## SH10 / Waipapa Road Intersection Improvements

**Road Safety Audit**  
**Scheme/Preliminary Design**

July 2017

**Figure 1: The proposed roundabout at the intersection of SH10, Waipapa Road and Waipapa Loop Road.**

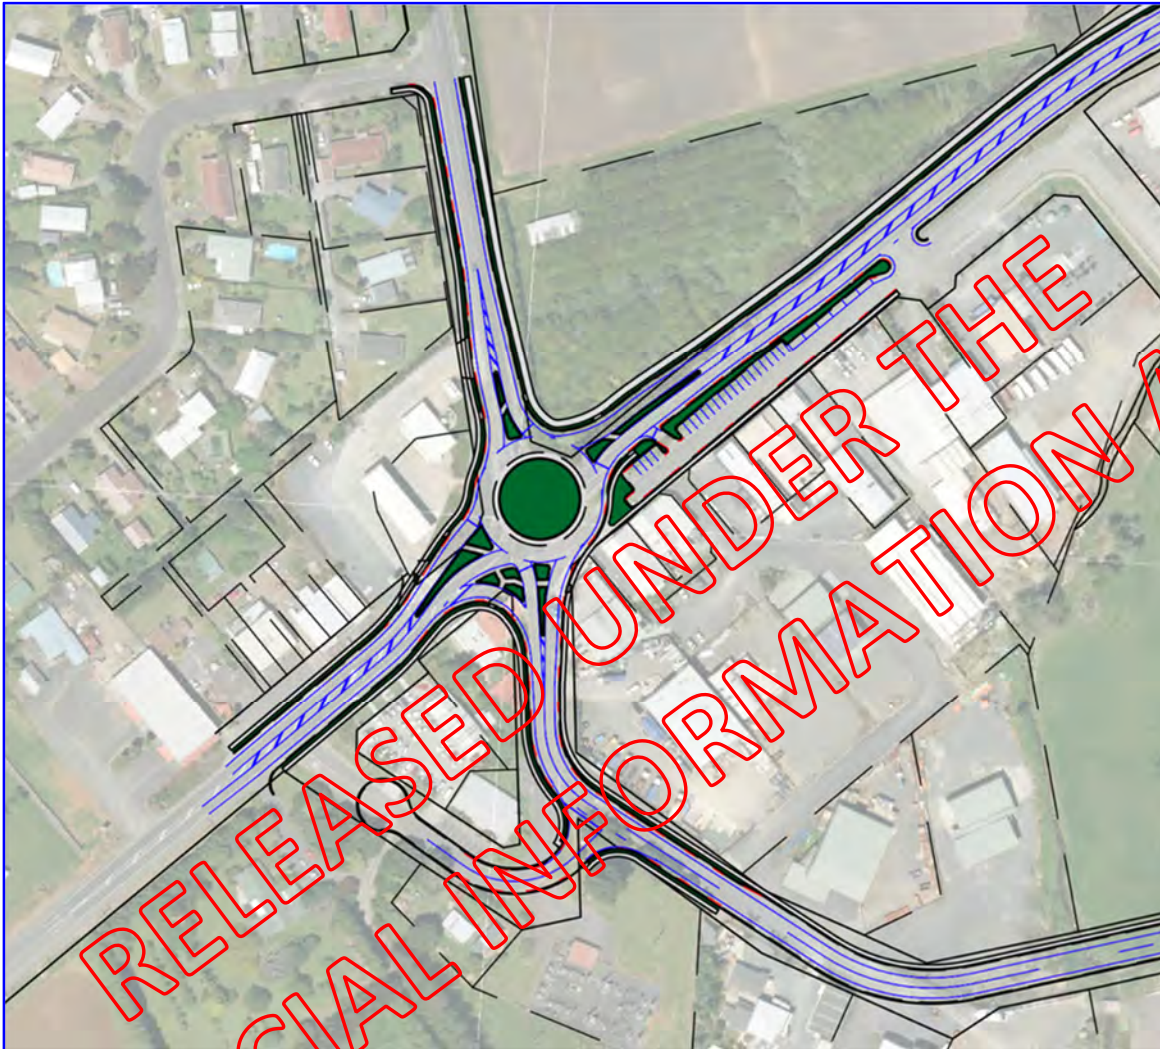
A 28 m inscribed diameter four-legged roundabout is proposed at the intersection of SH10, Waipapa Road and Waipapa Loop Road (refer to **Figure 1**). No details have been provided regarding other options that have been considered for the form of treatment for the intersection. Other treatments could include reconfiguration of a priority controlled intersection, signalisation, alternative roundabout configurations or an alternative location for the intersection. Therefore, the auditors are unable to comment on whether the form and location of the roundabout is the best solution in terms of a safe system design for this specific location.

The consideration of alternative roundabout configurations is desirable, as the skewed configuration results in faster left turn layouts on the obtuse angled exits. Faster exit speeds increase the likelihood of loss of control type crashes and the potential for higher speed crashes involving pedestrians crossing the road near the exits. An alternative configuration may also be useful in addressing specific safety concerns raised in this audit relating to the proposed design.

*Consider alternative roundabout configurations and/or locations, to improve safety performance and to address other specific safety concerns raised in this audit. These alternatives could include increasing the roundabout inscribed diameter or making the roundabout elliptical.*

| <b>Designer Response: Alternative configurations have been considered, including an elliptical roundabout. While it is agreed that it may be possible to design out some of the issues by re-locating the intersection, it has been found that this will have other effects, such as impact on the community, businesses and/or additional cost.</b> |                   |                         |               |

**Figure 2: The proposed central flush median corridor treatment.**

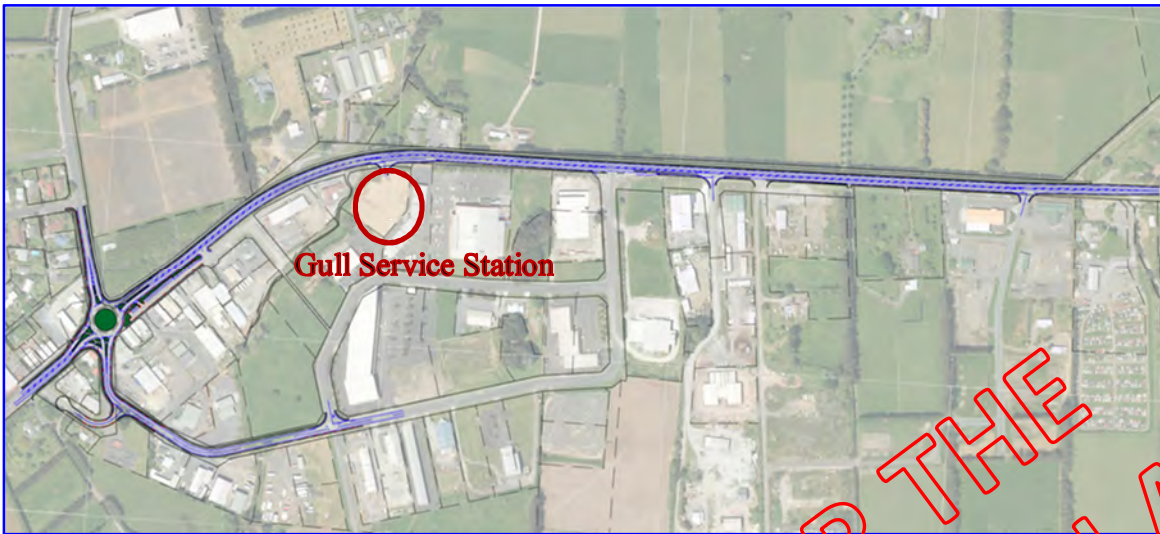
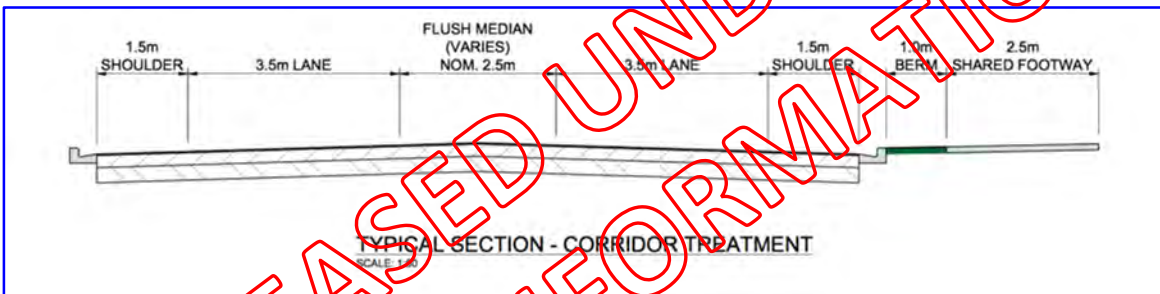
The project includes the widening of a 1.5 km length of SH10 and the provision of a 2.5 m wide central flush median, 1.5 m wide shoulders and a 2.5 m wide shared path along the eastern side of the road between the Kerikeri River Rest Area and Waipapa Road (refer to **Figures 2 and 3**).

The auditors note that this section of SH10 is a monitored crash reduction study site (CRS Site 36: Kahikatea Lane). Crash commonality includes rear end and turning crash movements, attributable to the frequency of high use accesses and an inconsistent road cross section. The proposed widening and provision of a central flush median is an appropriate treatment to address the crash history. Opus has advised that the inclusion of the SH10 corridor improvements in the project are not yet certain. The auditors recommend that these improvements be included in the project to address the crash history and provide a safe and consistent road environment through this length of SH10. Should this work not be included, then the auditors recommend that the median be provided south of the roundabout to the existing right turn bay at the Gull Service Station as a minimum treatment (refer to **Figure 2**).

*Include the SHHO corridor improvements in the project implementation. Should this work not proceed, then provide a central flush median south of the roundabout to the existing right turn bay at the Gull Service Station.*

| <b>Designer Response: Agree. The corridor improvements have been included in the Detailed Business Case, which will form the basis of the funding application.</b> |                 |                         |                 |

**Figure 4: The free flow left turn from Waipapa Loop Road to SH10.**

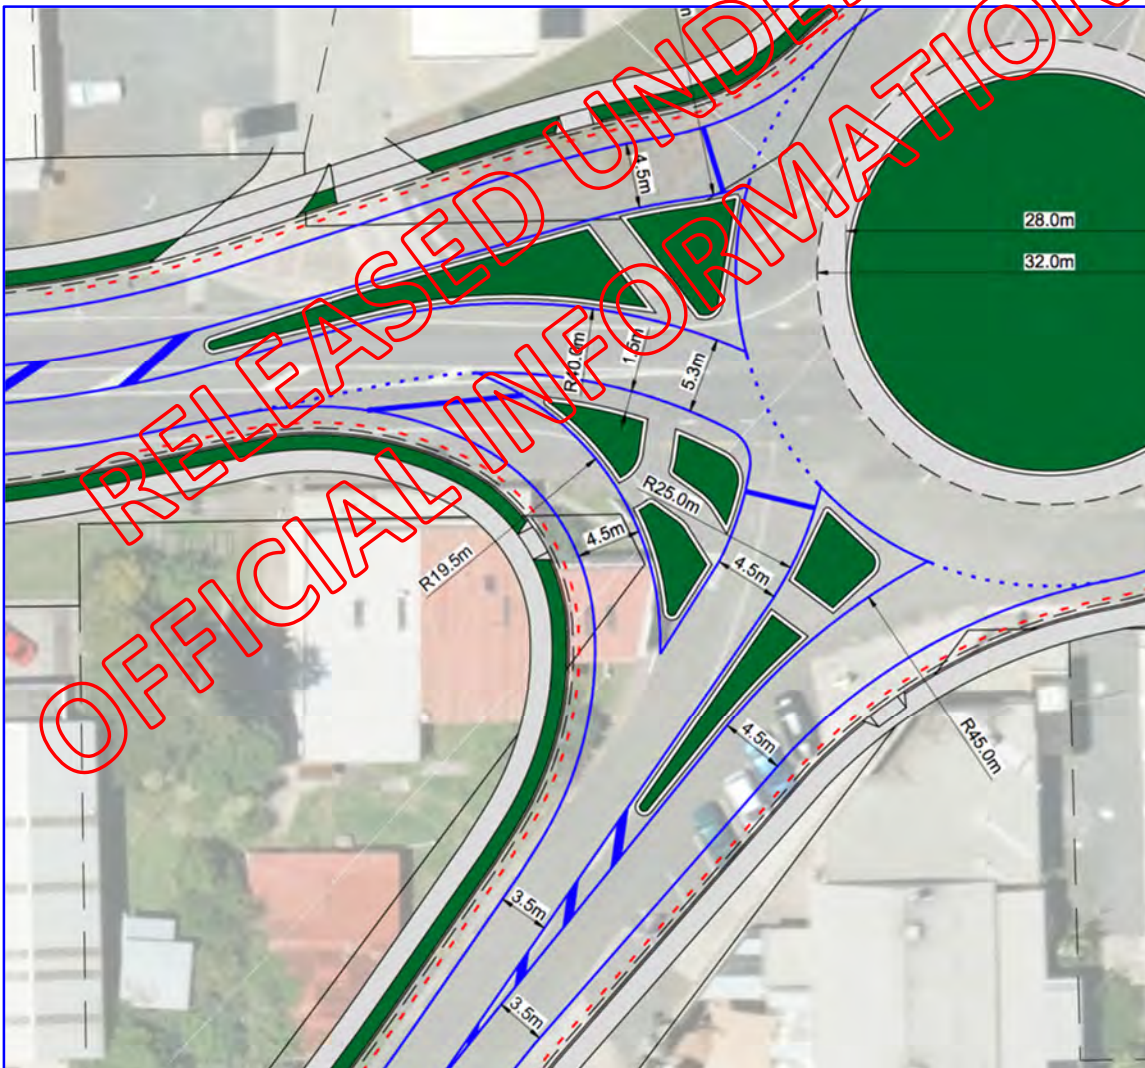
There is an acute angle left turn free flow lane from Waipapa Loop Road to SH10 (refer to **Figure 4**). This creates an unorthodox layout for vehicles and pedestrians that introduces additional crossing points for pedestrians. This complicates pedestrian wayfinding, increases the number of vehicle versus pedestrian conflicts and increases difficulties for pedestrians to make safe decisions for crossing the road (on occasions the intended route of an approaching vehicle may be unclear until the last moment). These factors increase the likelihood of vehicle versus pedestrian crashes that result in high injury severity and is an unsafe configuration for pedestrians in an urban environment.

The auditors consider that the free flow left turn lane should be removed, with a design similar to the left turn from Waipapa Road to SH10 (south) provided as a safer alternative. This may be able to be achieved by increasing the inscribed diameter of the roundabout or by providing an elliptical central island.

*Remove the free flow left turn from Waipapa Loop Road to SH10 and consider alternative geometric configurations for the roundabout to accommodate left turns within the roundabout circulatory roadway.*

| <b>Designer Response: Agree. This will be confirmed during Detailed Design.</b> |               |                         |               |

**Figure 5:** The crossing points within the entry islands are not perpendicular to the opposite crossing points

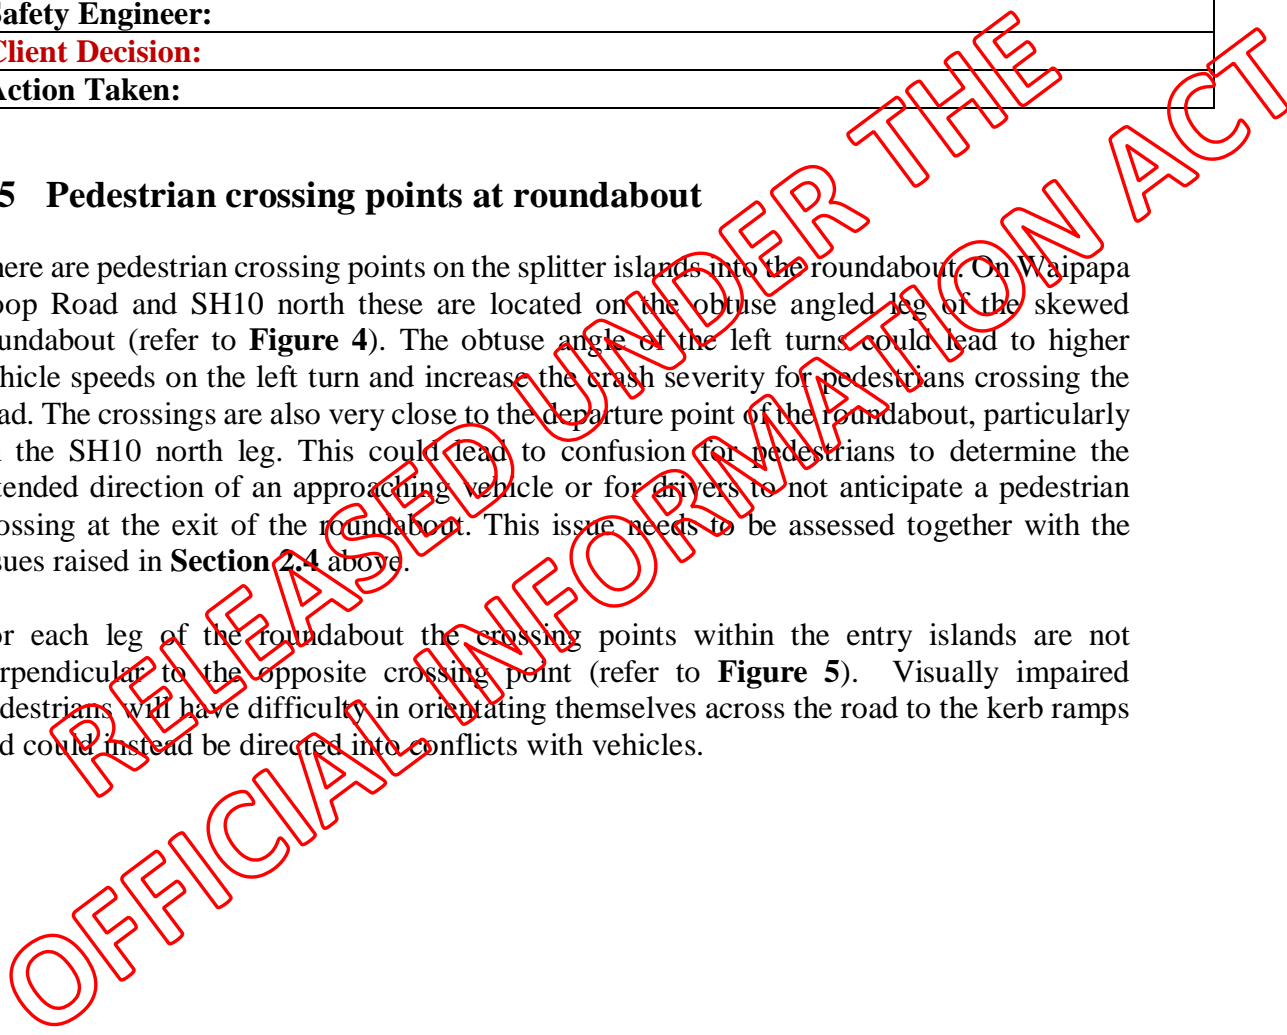
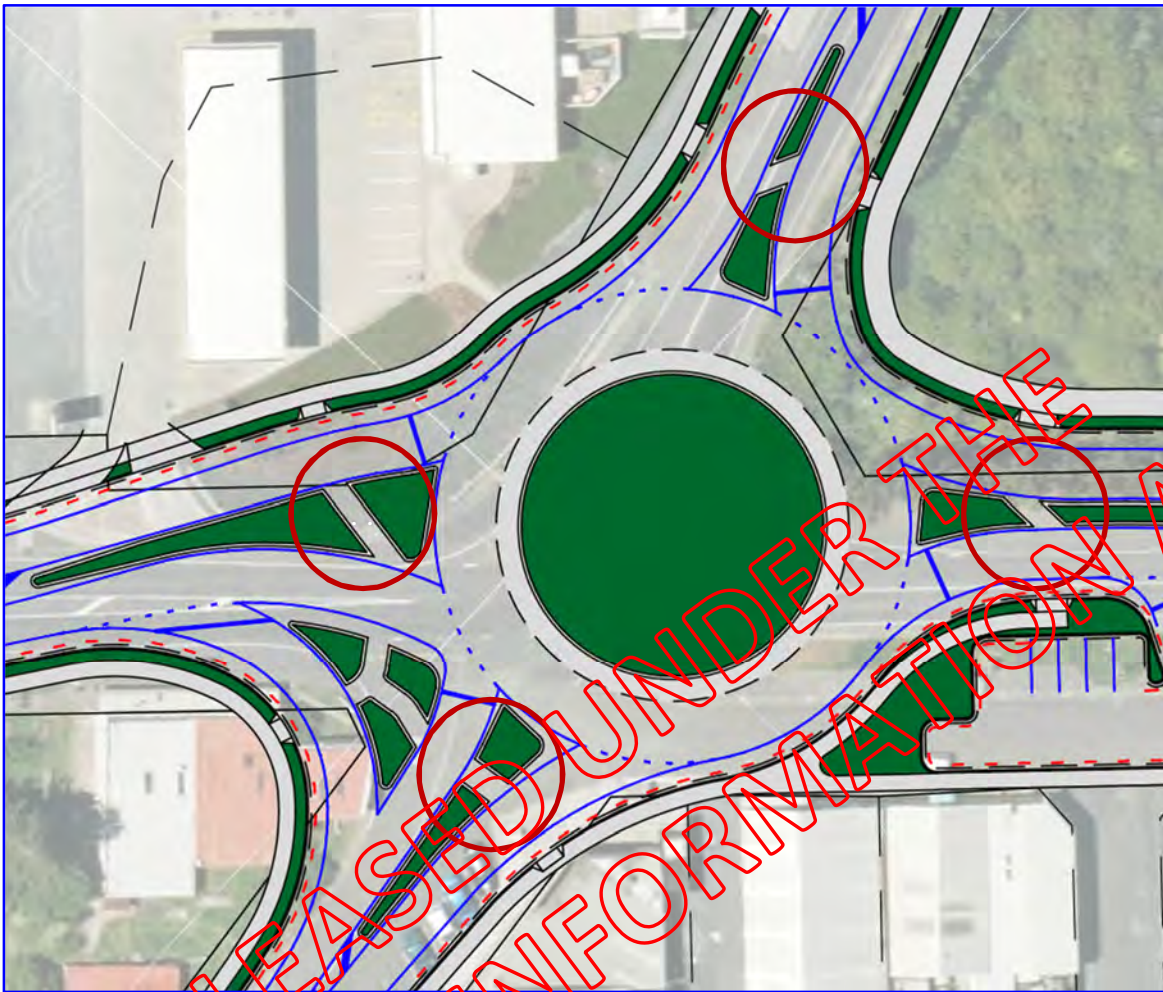
There are pedestrian crossing points on the splitter islands into the roundabout. On Waipapa Loop Road and SH10 north these are located on the obtuse angled leg of the skewed roundabout (refer to **Figure 4**). The obtuse angle of the left turns could lead to higher vehicle speeds on the left turn and increase the crash severity for pedestrians crossing the road. The crossings are also very close to the departure point of the roundabout, particularly on the SH10 north leg. This could lead to confusion for pedestrians to determine the intended direction of an approaching vehicle or for drivers to not anticipate a pedestrian crossing at the exit of the roundabout. This issue needs to be assessed together with the issues raised in **Section 2.4** above.

For each leg of the roundabout the crossing points within the entry islands are not perpendicular to the opposite crossing point (refer to **Figure 5**). Visually impaired pedestrians will have difficulty in orientating themselves across the road to the kerb ramps and could instead be directed into conflicts with vehicles.

- a) Move the pedestrian crossing points on the entry islands further back on the Waipapa Loop Road and SH10 north approaches.

b) Orientate the pedestrian crossing points on the entry islands perpendicular to the opposite crossing point.

| <b>Designer Response: Noted. The location of the pedestrian crossing points will need to balance the issues raised above with the pedestrian desire lines.</b> |               |                         |               |

| <b>Designer Response: Pedestrian crossing points are angled to encourage pedestrians to face oncoming traffic. Visually impaired pedestrians will be guided by tactile paving, which will be aligned.</b> |               |                         |               |

**Figure 6: The proposed closure of the northern intersection of Waipapa Loop Road with SH10, with a cul-de-sac treatment.**

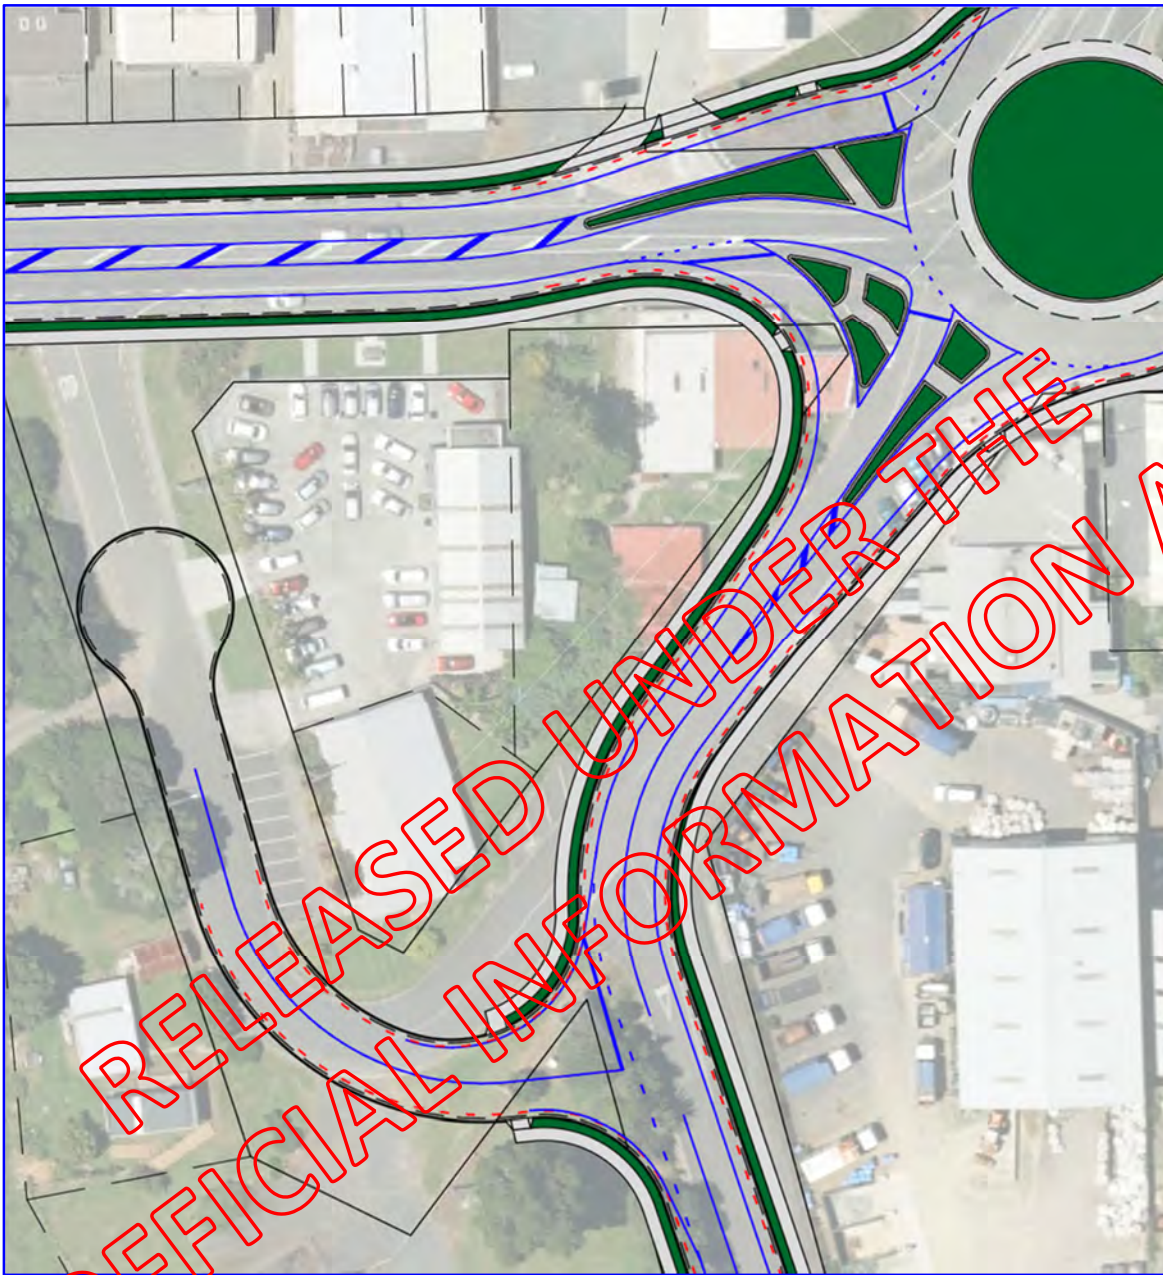
The closure of the northern intersection of Waipapa Loop Road with SH10, with a cul-de-sac treatment on the end of Waipapa Loop Road is proposed (refer to Figure 6). Opus has asked the audit team to comment on an option for left in/left out treatments at this intersection, noting that dairy tankers access a farm on Waipapa Loop Road. The auditors favour a left in/left out only configuration for the intersection, as:

- This will be beneficial in addressing the safety concerns associated with the acute angle left turn free flow lanes from Waipapa Loop Road to SH10, discussed in **Section 2.4** above; and
- Turning movements for dairy tankers will be more easily provided for at this location, rather than the acute angle at the roundabout.

The proposed configuration for the intersection of Waipapa Loop Road with Maritime Way will not provide for the tracking of a dairy tanker and will need to be revised if the proposed cul-de-sac is constructed. The intersection throat is relatively large. The provision of a throat island and pedestrian refuge would be beneficial to reduce vehicle speeds and walking distances through the intersection.

- a) *Provide a left in/left out configuration at the Waipapa Loop Road / SH10 intersection.*

- b) *Provide adequate tracking for dairy tankers to access the farm on Waipapa Loop Road.*

- c) *Consider providing a throat island and pedestrian refuge at the intersection of Waipapa Loop Road and Maritime Way.*

| <b>Designer Response: Agree in part. May be left out only. To be determined through Detailed Design.</b> |               |                         |               |

| <b>Designer Response: Agree.</b> |               |                         |                 |

| <b>Designer Response: Agree. To be considered during Detailed Design.</b> |               |                         |                 |
